KWM-380 TRANSCEIVER (622-5093-101)  
HF-380 TRANSCEIVER (622-3580-101)  
RECEIVER-EXCITER CIRCUIT CARD A3 (638-6908-001)

SERVICE BULLETIN NO 1

PRODUCT IMPROVEMENT

P/O Receiver-Exciter Circuit Card A3.  
Figure 1 (Sheet 2)

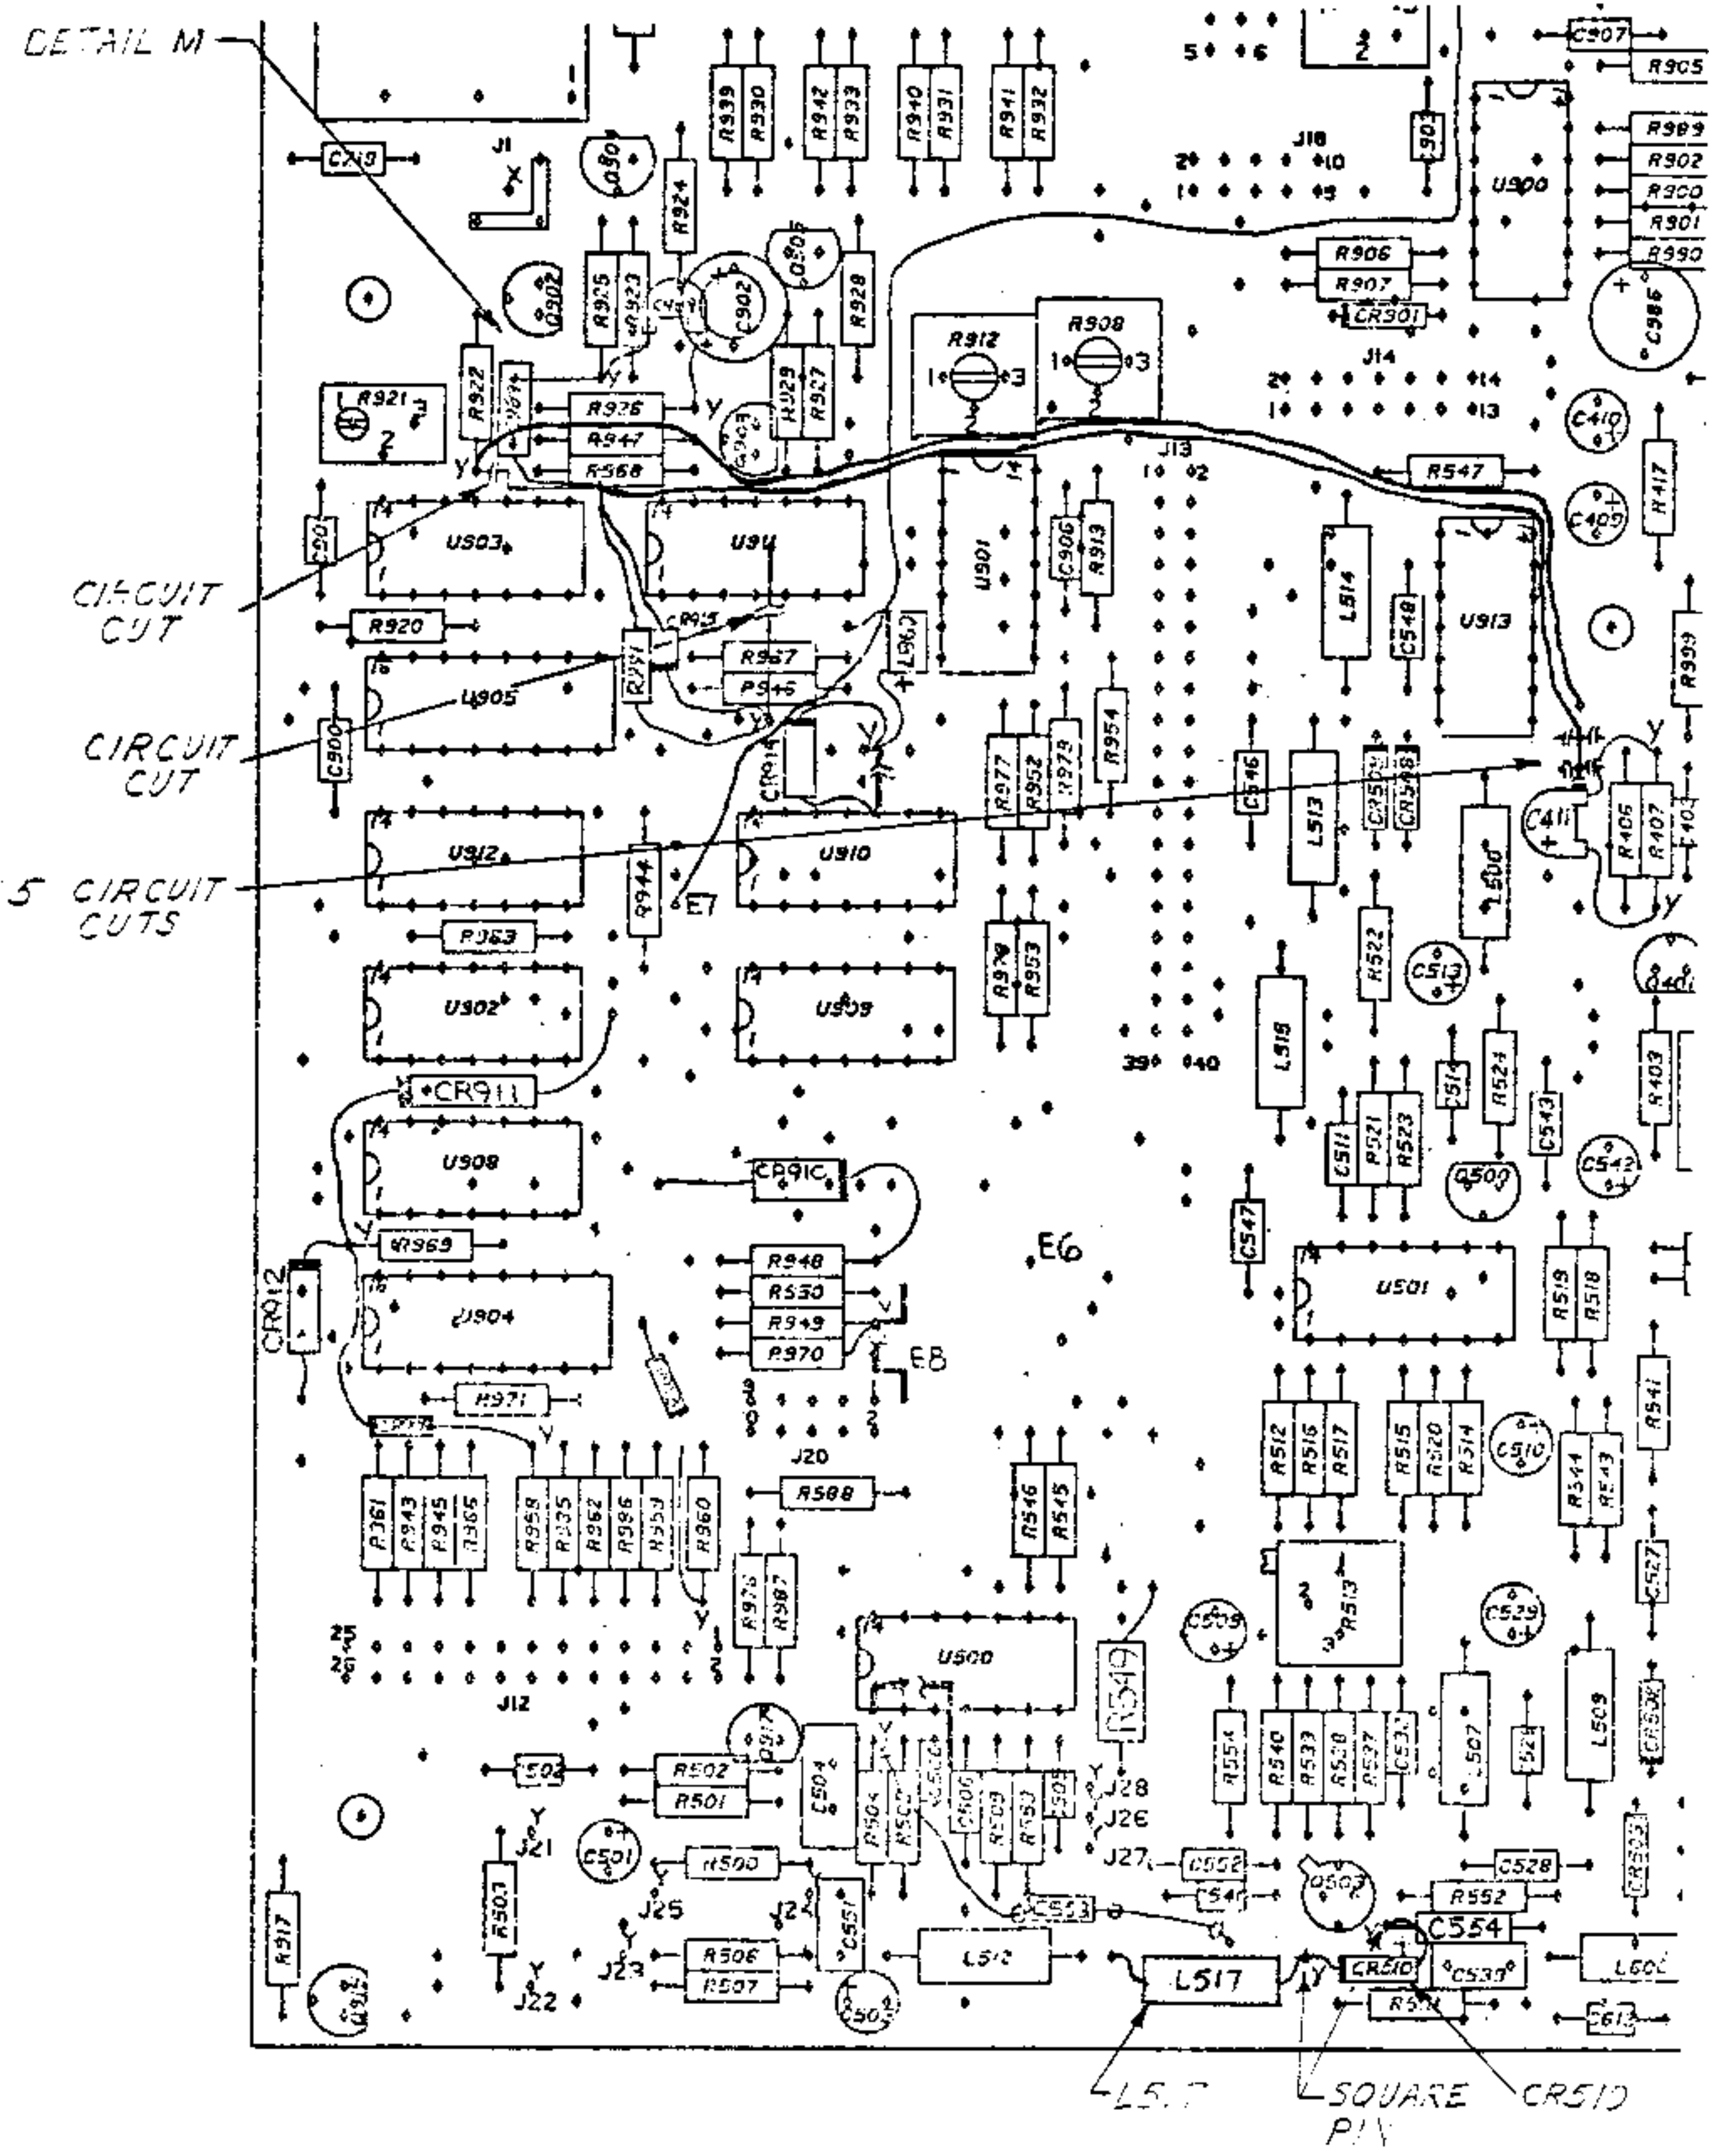
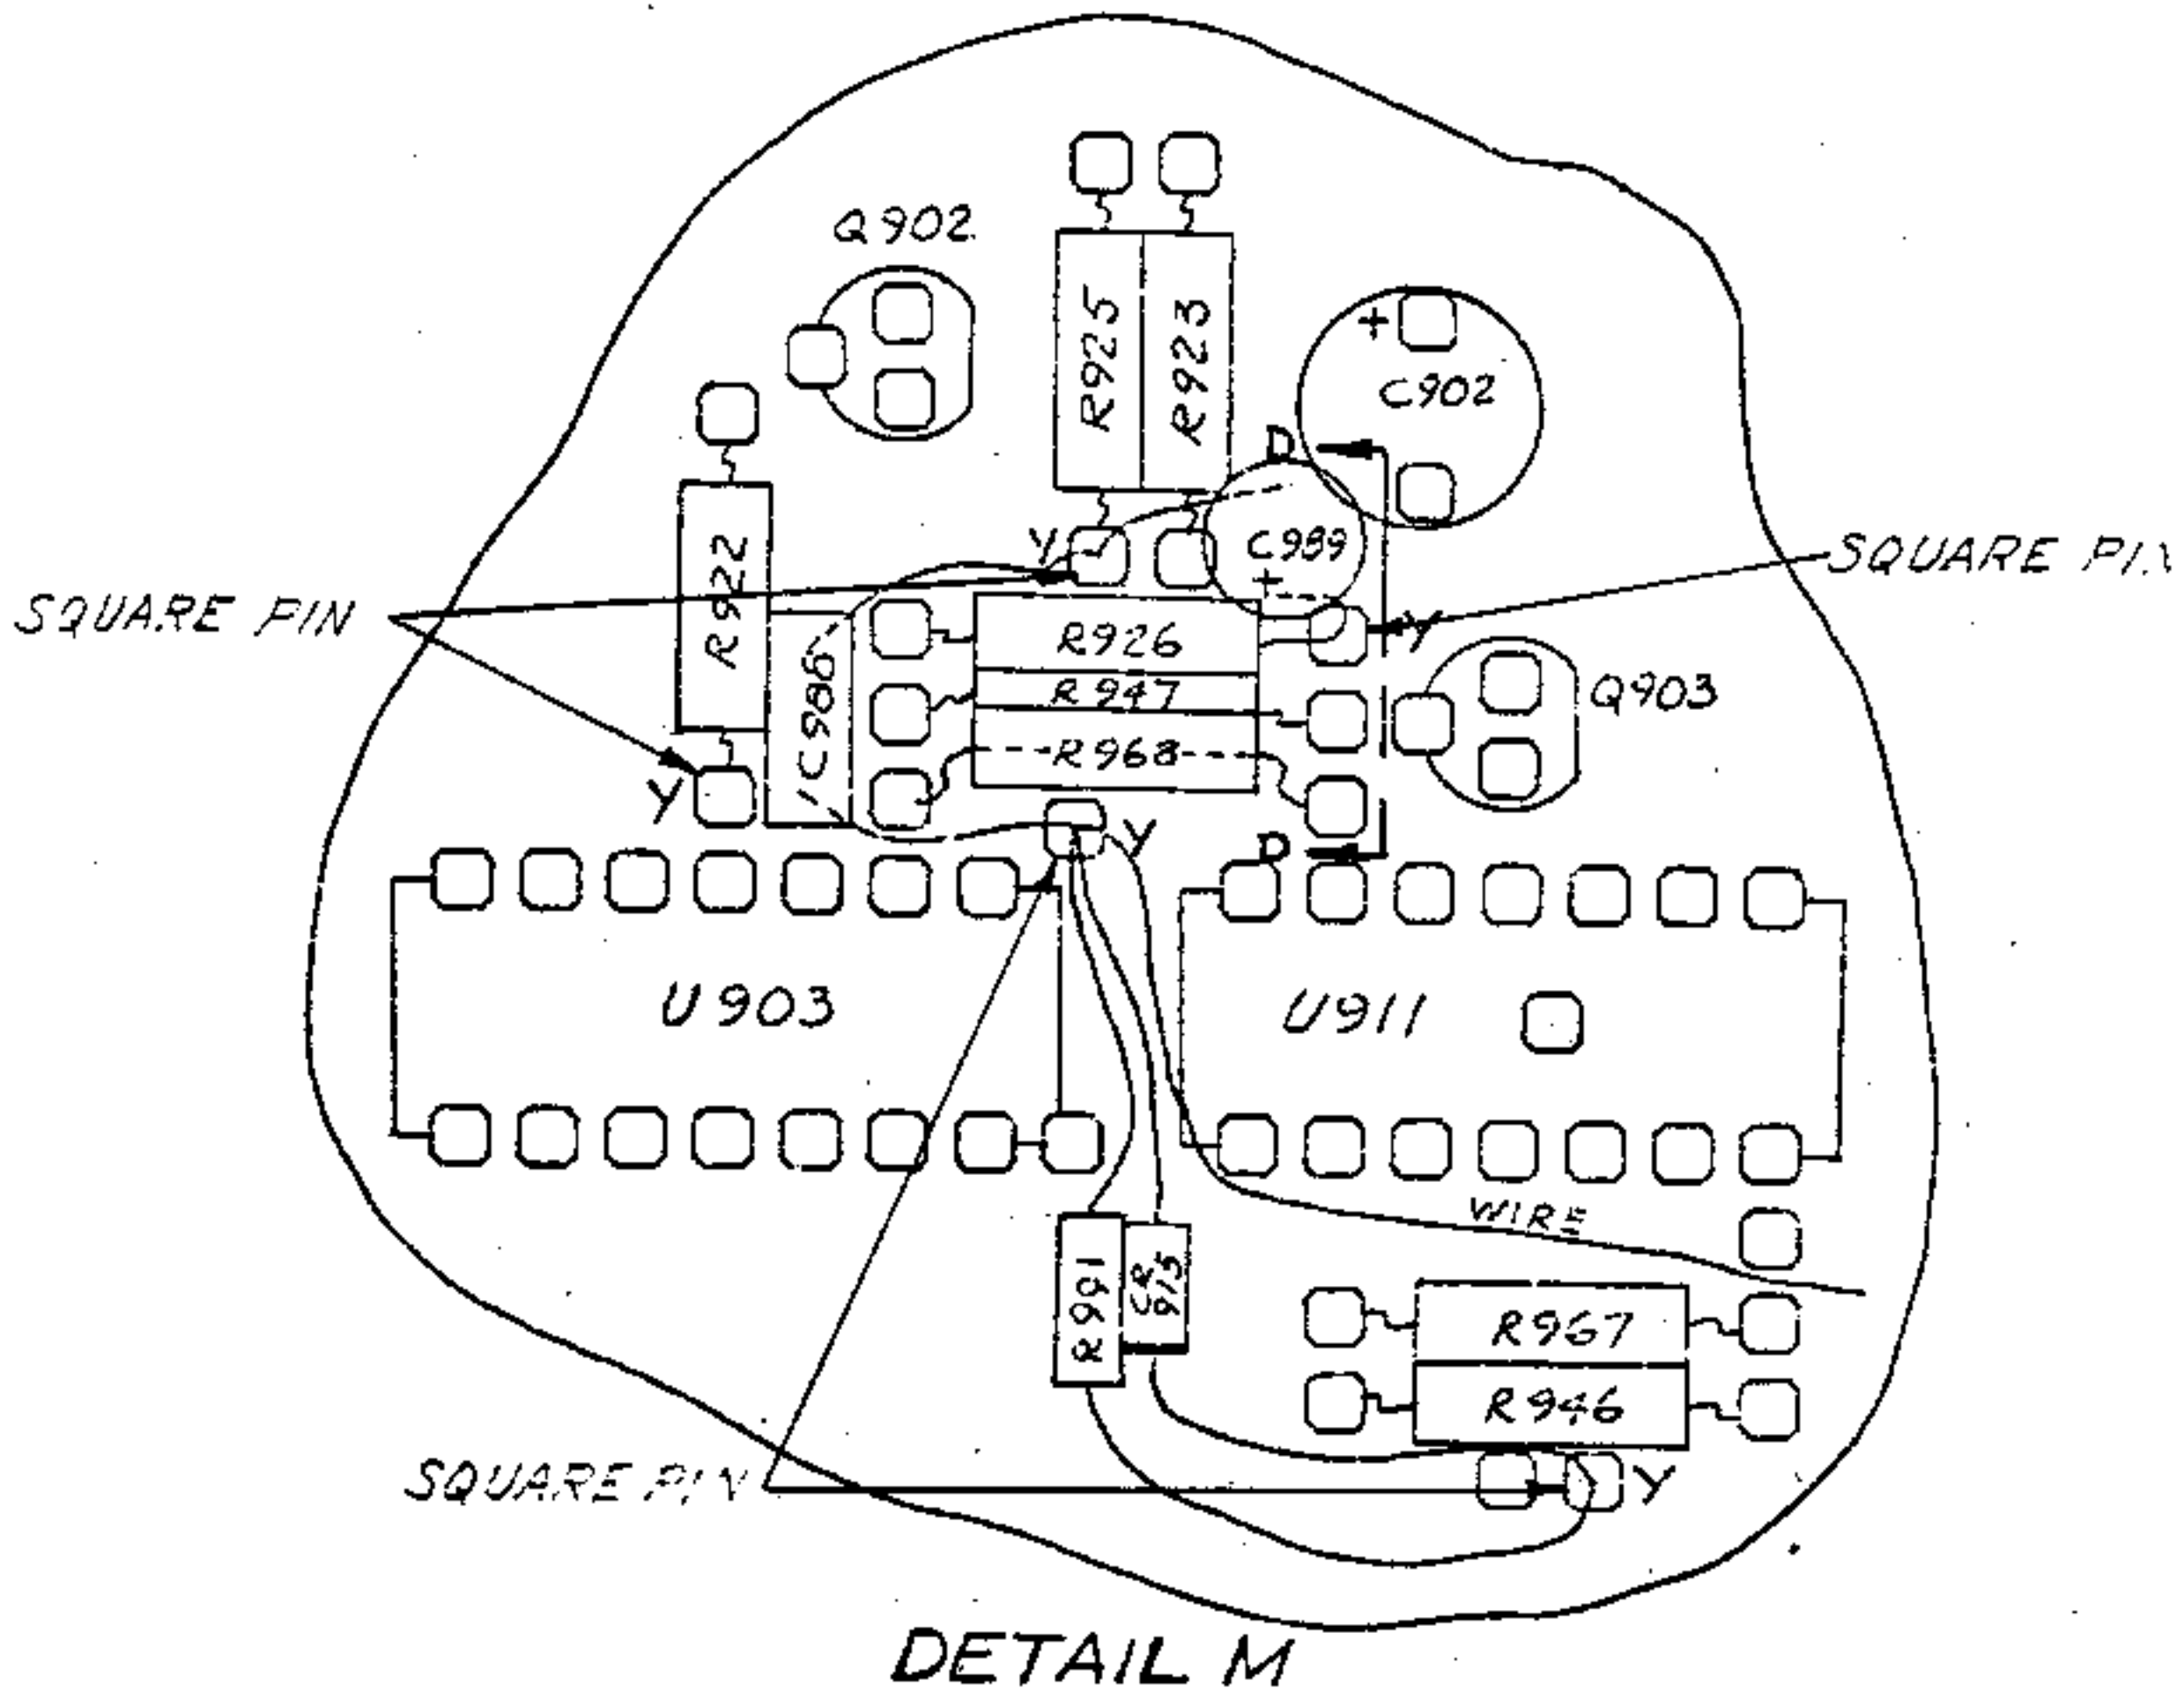
- H. Refer to figure 1, detail M, for location and install five square pins (372-2601-045). Lift component leads, as necessary, and reconnect the leads to the pins after the square pins are installed.

- K. Install a jumper wire (428-0282-050) from the square pin at the bottom lead of R922 to the thru hole to the right of U913-9.

- L. Install a jumper wire (428-0282-050) from the square pin just below R968 to the thru hole to the right of U913-8.
- M. Remove 47- $\mu$ F capacitor C902 and replace it with a 10- $\mu$ F capacitor (184-9102-610).

- N. Install 0.1- $\mu$ F capacitor C988 (913-5019-440) from the square pin at the bottom lead of R925 to the square pin below R968.
- O. Install 1.5- $\mu$ F capacitor C989 (184-9102-800) with the positive lead connected to the square pin at the right-hand lead of R926 and the other lead connected to the square pin at the bottom of R925. Refer to figure 1, detail M, section D-D.
